ADDENDUM NO. 5

RFP #11-029

Date: 12-2-11
To: All Interested Parties
From: Steve Gibson
GRP Division Buyer
San Jacinto River Authority

01E-102

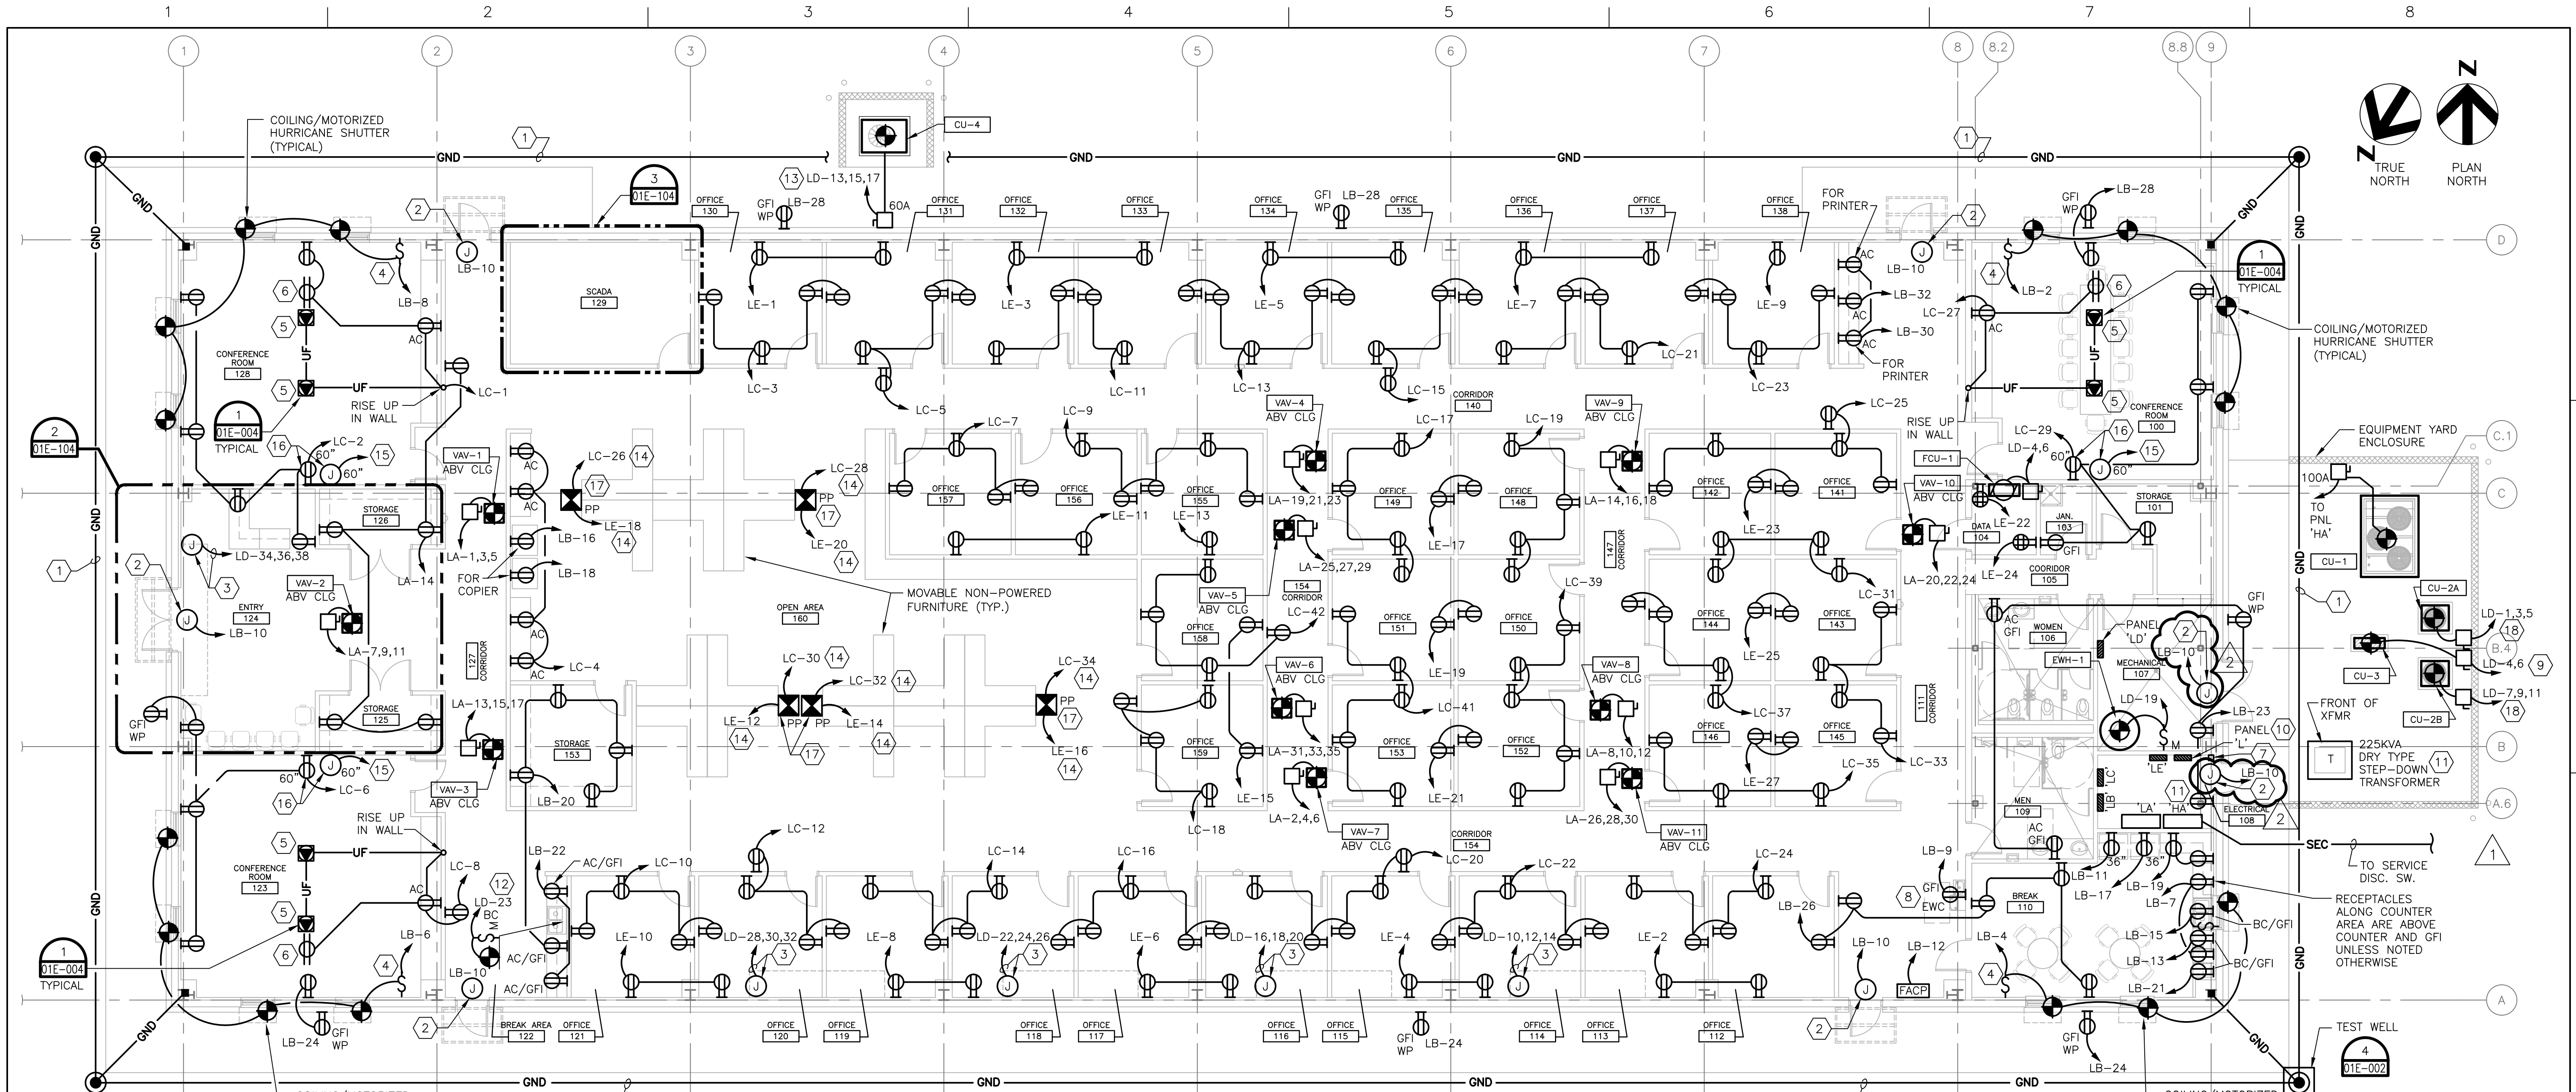
The revised sheet (01E-102) includes the addition of J-boxes for future card readers at exterior doors 106A and 107
